SERVICE BULLETIN

M-957

LATE 1988 1340cc RUBBER MOUNT VEHICLES PIVOT BOLT RETAINER

Figure 1. Retaining Clip Installation

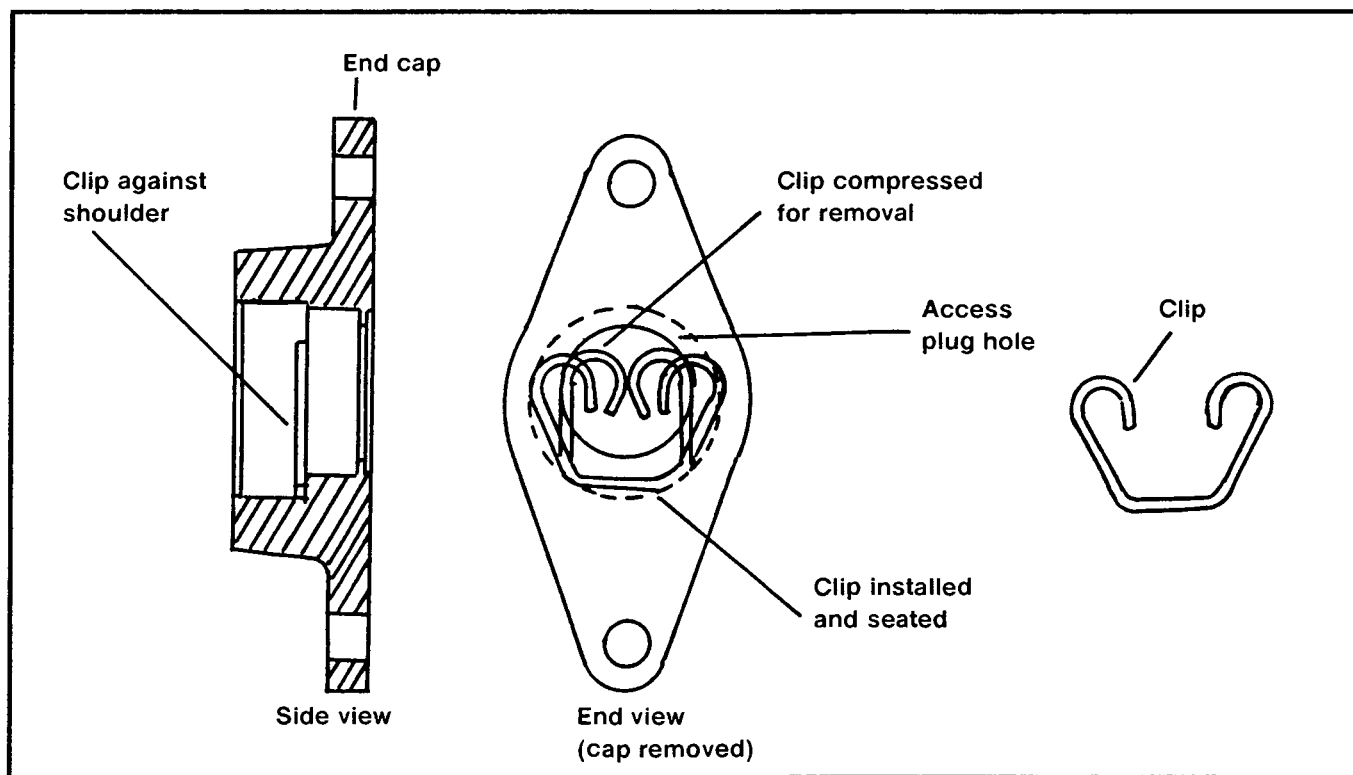
This Bulletin is to advise you of a retaining clip that was added as a running change to 1988 rubber mount motorcycles.

See Figure 1. The clip can be installed and removed from the outside of either end cap by removing the access plug. Compress the looped ends of the clip with a needle nose pliers and insert or remove the clip through the access plug hole. The clip is seated against the outside shoulder of the large diameter bore in the end cap.

Position the clip so that the flat center portion of the clip is at the bottom of the bore where the offset is the greatest.

The clip can be ordered through regular parts channels by specifying H.D. Part No. 47819-87. The clip can be used on earlier models where the late style pivot shaft (introduced in mid. 1986) is used.
